Addendum 2

DATE	11/13/2026
PROJECT NAME	BL572 – Intercollegiate Athletics Gymnasium – First Floor HVAC & Lighting Upgrades
INTROBA PROJECT #	2035.0013084.001
IU PROJECT #	20250522
DISTRIBUTION	Owner
ADDENDUM CONSIST OF	(32) 8.5 x 11 PAGES & (53) 30 x 42 PAGES

A BL572 - LEVEL 2
PARTIAL FLOOR PLAN
SCALE: 1/8" = 1'-0"

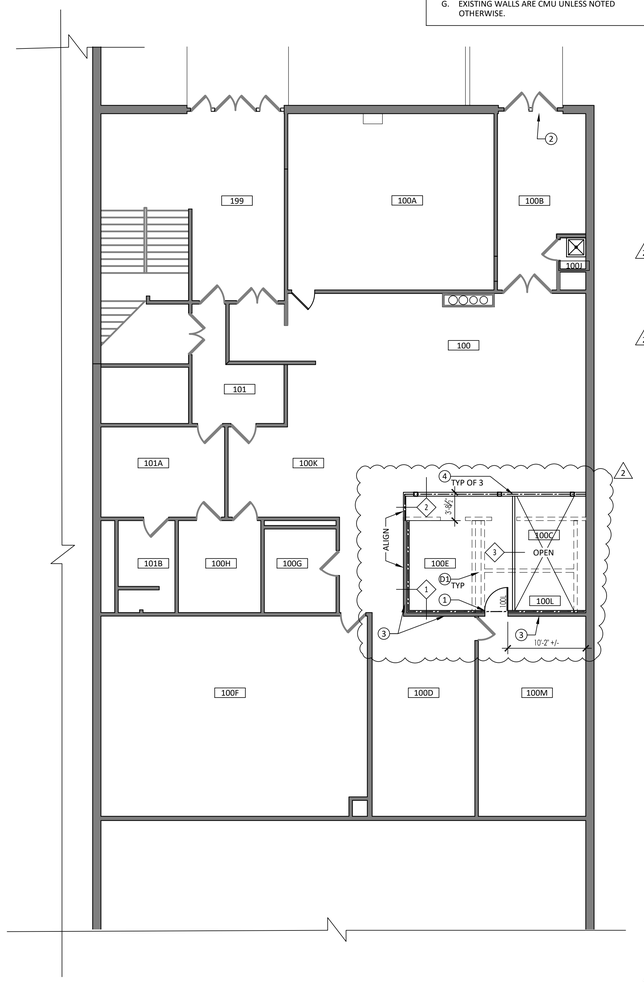
1. Change FLOOR PLAN NOTE 1 as indicated on attached drawings.
2. Add WALL TYPE 3 as indicated on attached drawings.
3. Add FLOOR PLAN NOTE 4 as indicated on attached drawings.
4. Change A/A-102 PARTIAL FLOOR PLAN as indicated on attached drawings.
5. Change DOOR AND FRAME SCHEDULE as indicated on attached drawings.

6. Change DOOR DETAILS as indicated on attached drawings.

DRAWING TITLE
PLUMBING DEMOLITION PLAN BL572 LEVEL 1 & 2

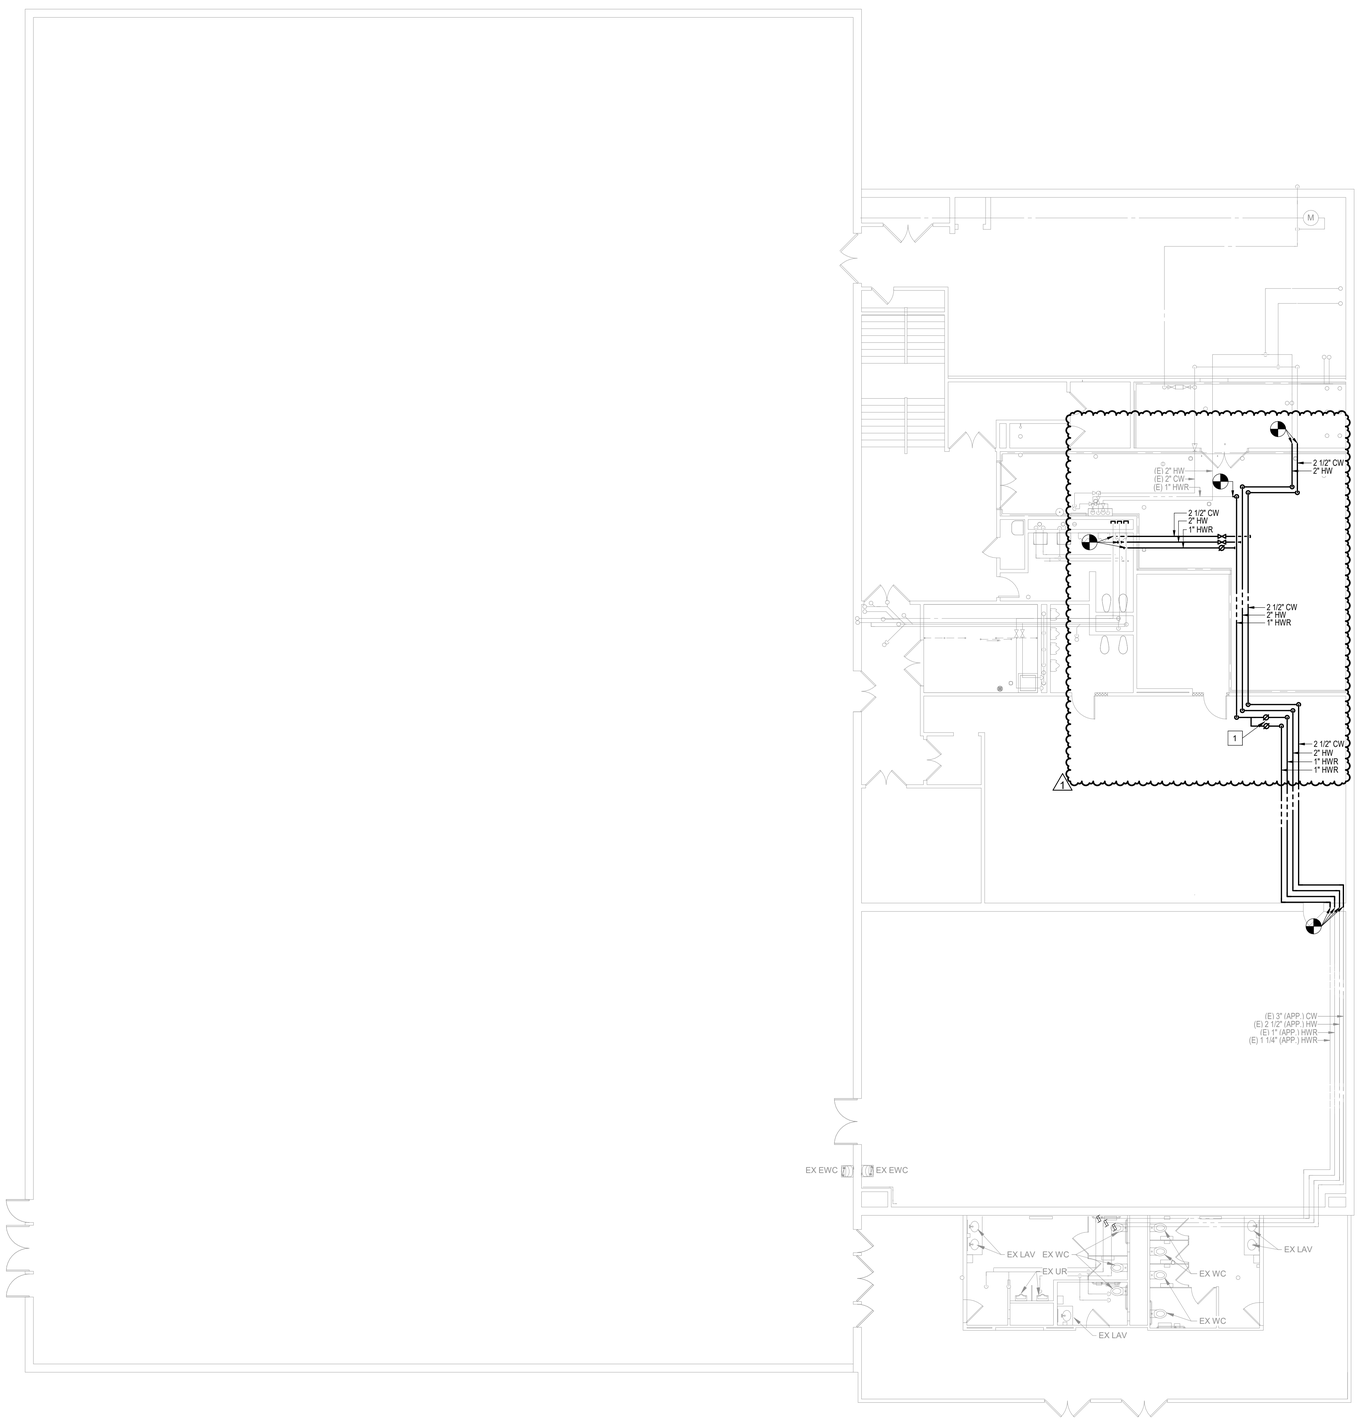
1. Modified piping locations to match existing conditions in 001C Mechanical Room.
2. Modified demolition extents in 001C Mechanical Room.

DRAWING TITLE
PLUMBING PLAN BL572 LEVEL 1 & 2

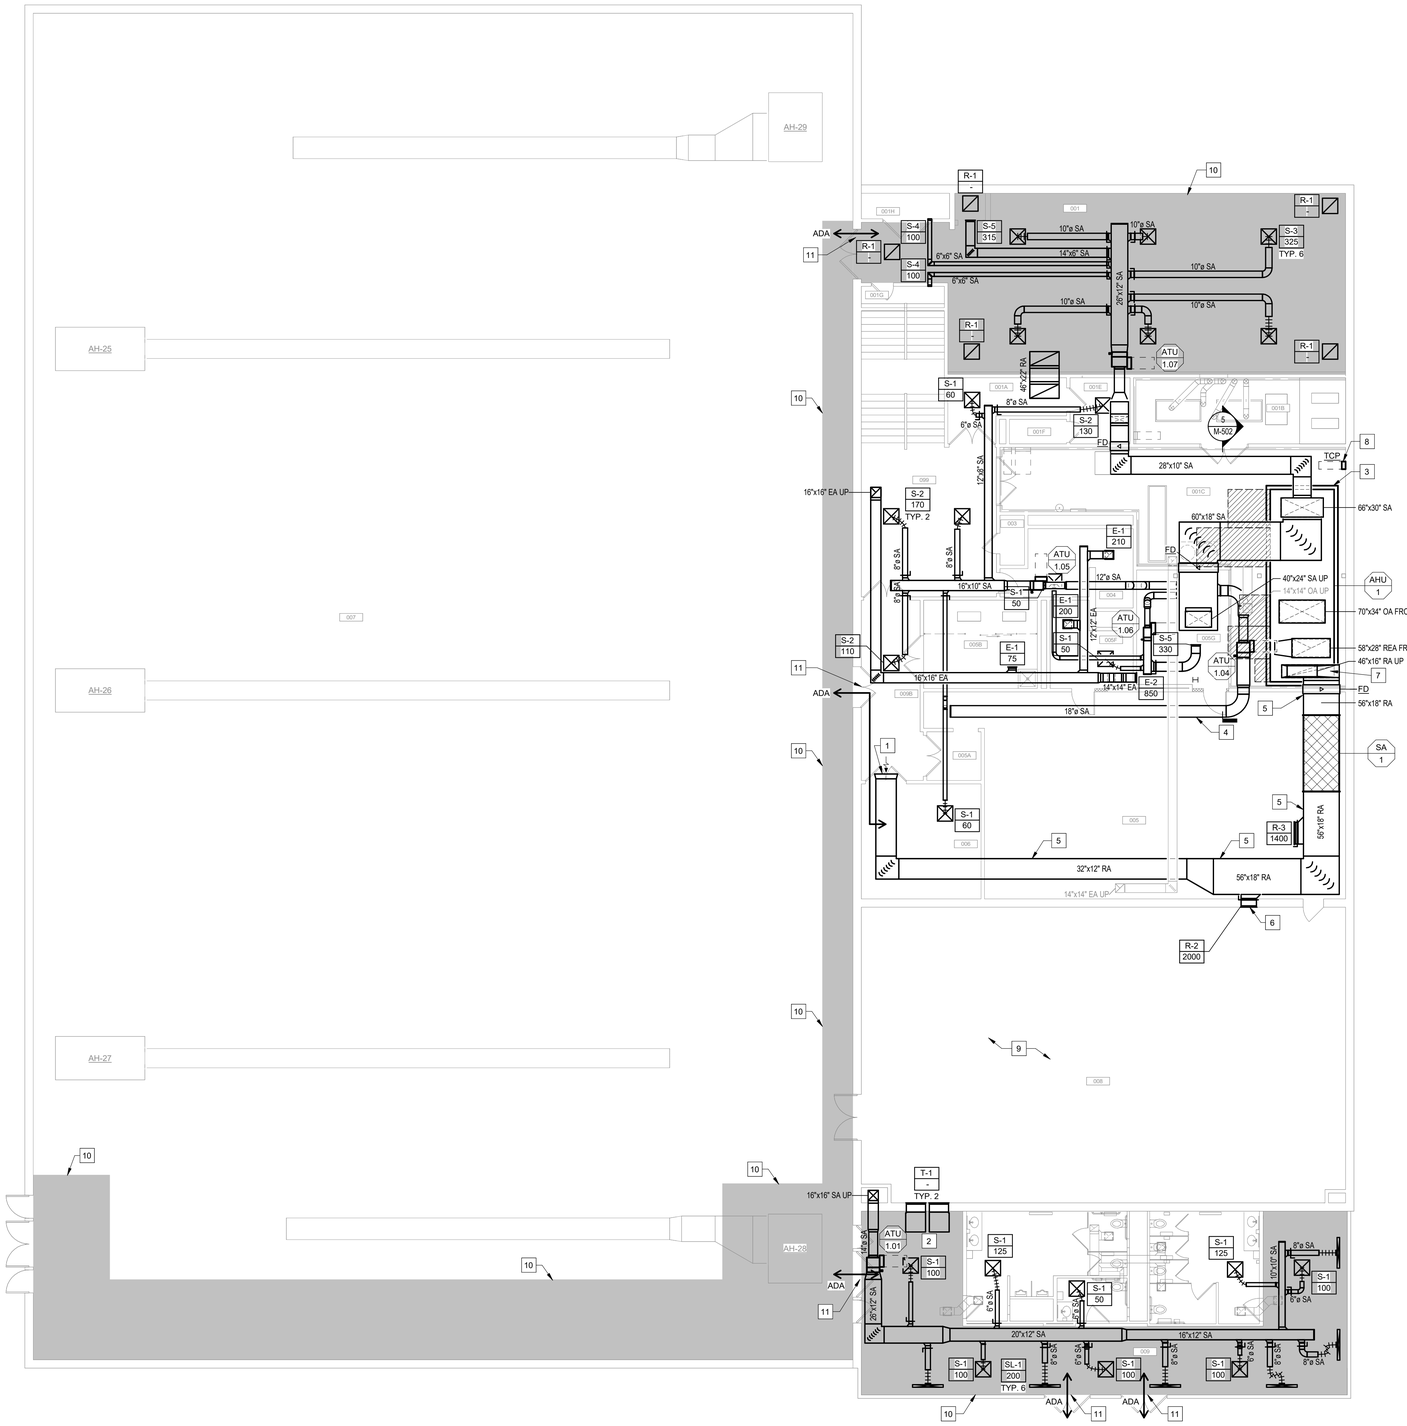
1. Modified routing of new piping in 001C Mechanical Room.

1 **MECHANICAL ALTERNATE DEMOLITION PLAN BL572 LEVEL 2**
1/8" = 1'-0"

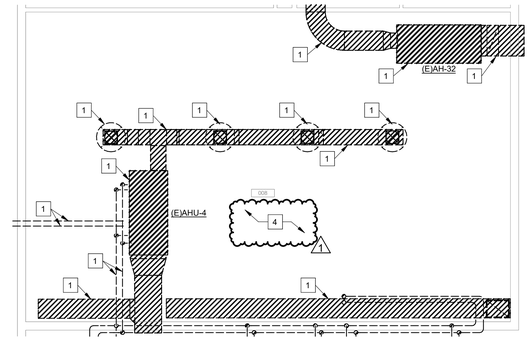
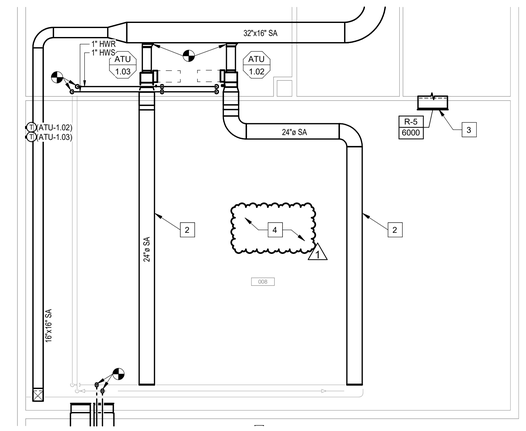
1. Added Sheet Note #4 to Sheet Keynotes and drawings.

DRAWING No.
E-202

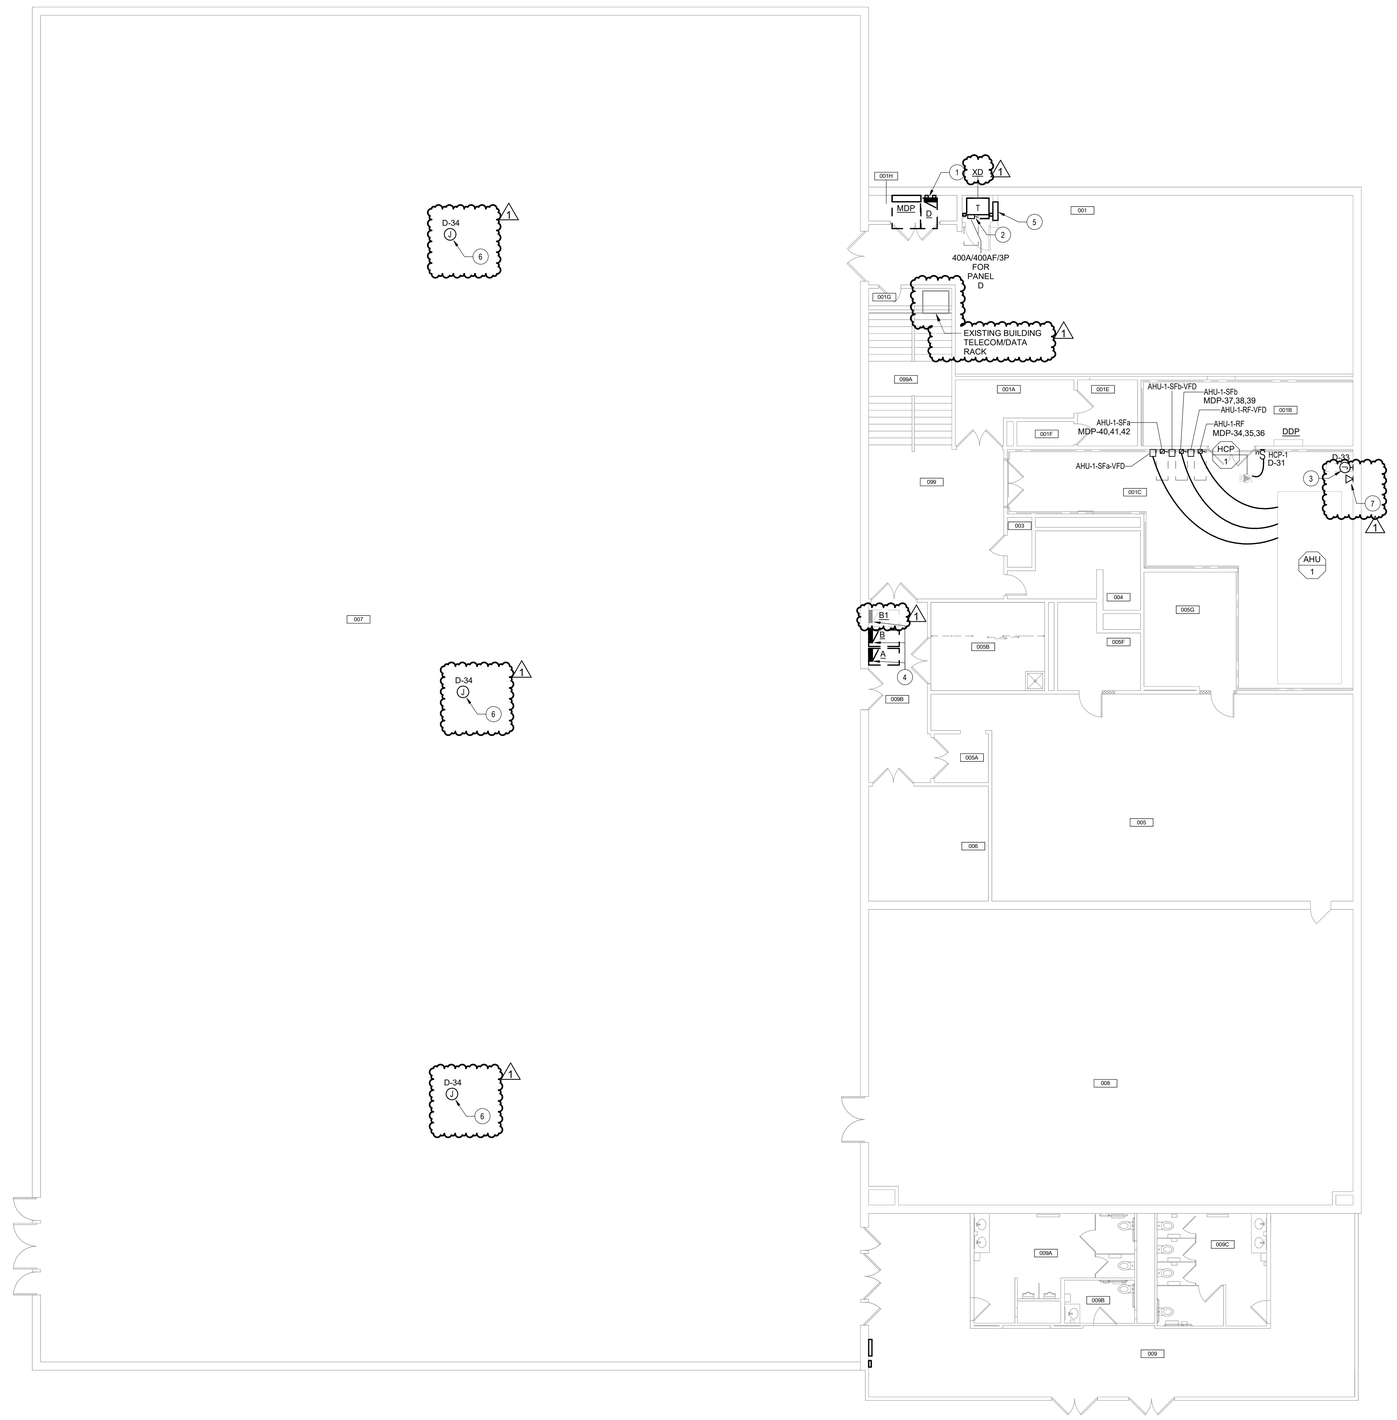
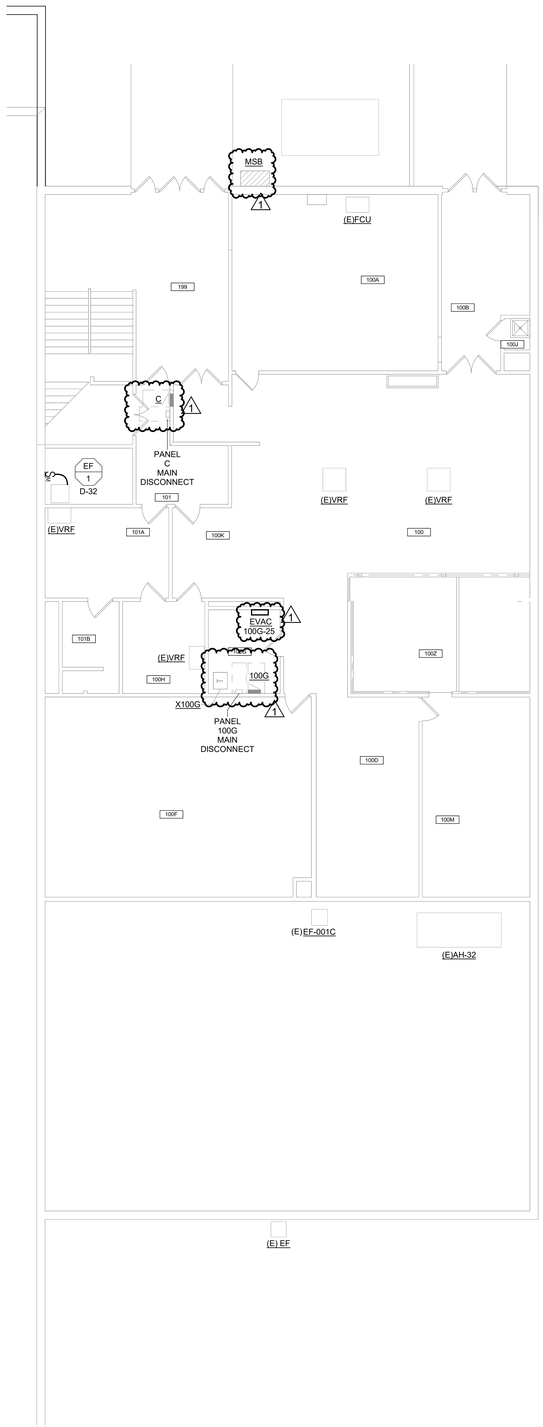
1. Added location for existing building telecom/data rack for reference.
2. Modified name for new 112.5kva transformer to XD.
3. Added additional power for high output fire alarm speaker units within gym.
4. Added data outlet for mechanical control panel.
5. Modified language of sheet note #2 for clarity.
6. Modified language of sheet note four to include shroud above and below panel.
7. Modified graphical representation of existing panels to clarify scope.

DRAWING TITLE
ELECTRICAL LIGHTING PLAN BL572 LEVEL 1

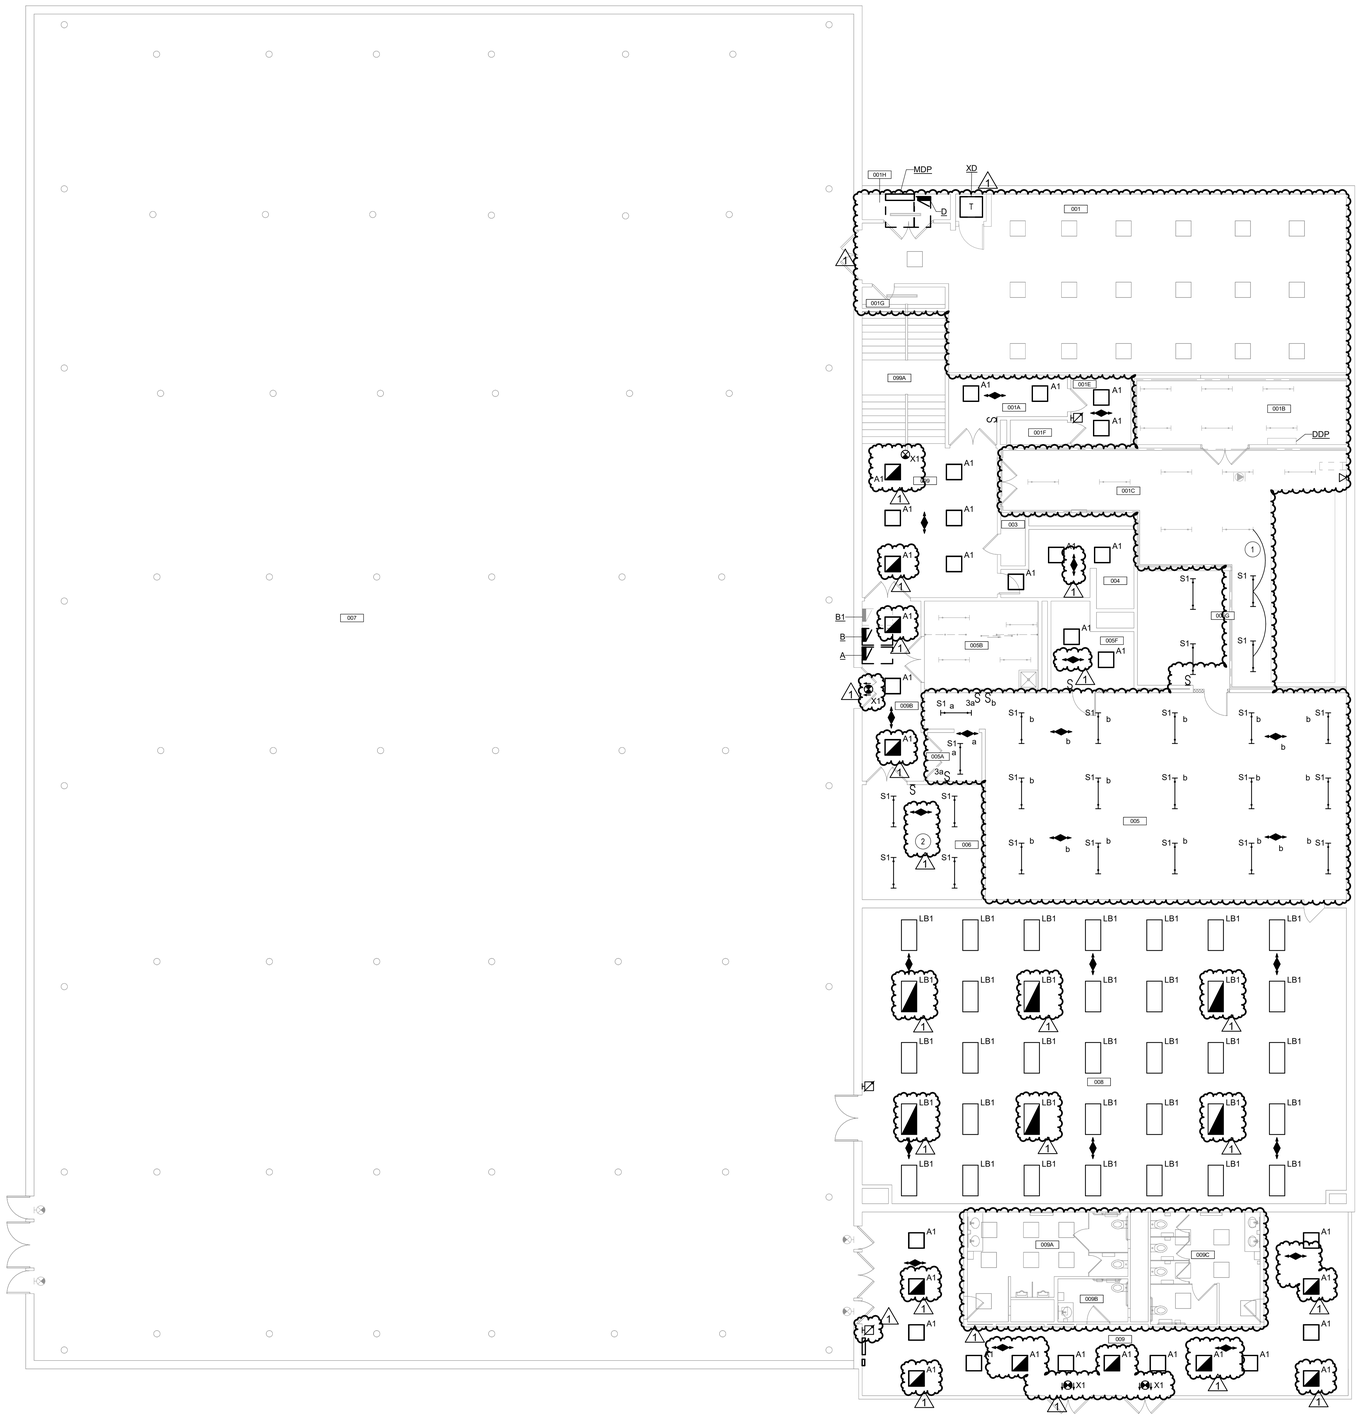
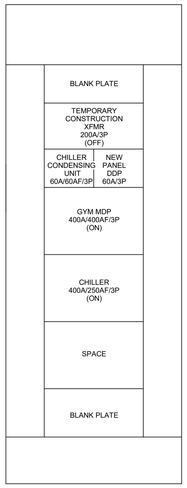
1. Modified lighting control within room 005 and 005A.
2. Added emergency lighting throughout floorplan.
3. Added replacement of exit signage throughout plans.
4. Modified graphical representation of existing to remain fixtures and equipment to clarify scope.
5. Added note for modification of fixture locations within room 006 according to existing fencing layout.
6. Added occupancy sensors throughout floorplan.
7. Added manual dimming control for room 009.

2 NEW SINGLE LINE DIAGRAM

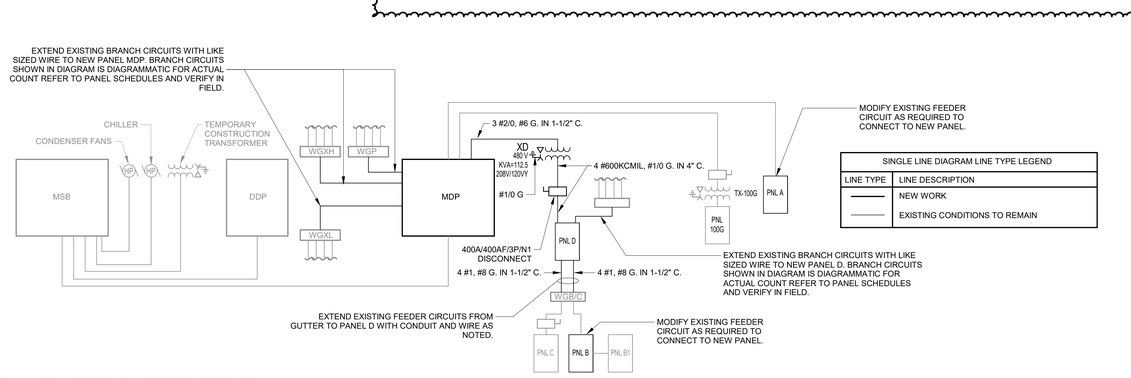
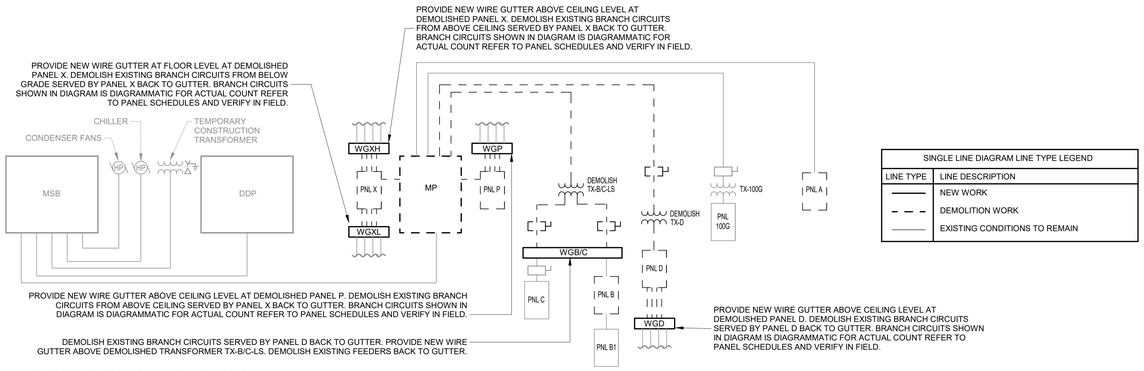
1. Modified sheet name.
2. Added demo and new single line diagrams.
3. Modified panel characteristics for all new panel schedules.
4. Updated branch circuiting per plan changes and single line changes.
5. Added notation for contractor to update all panel directories and trace unknown circuits as required to update.
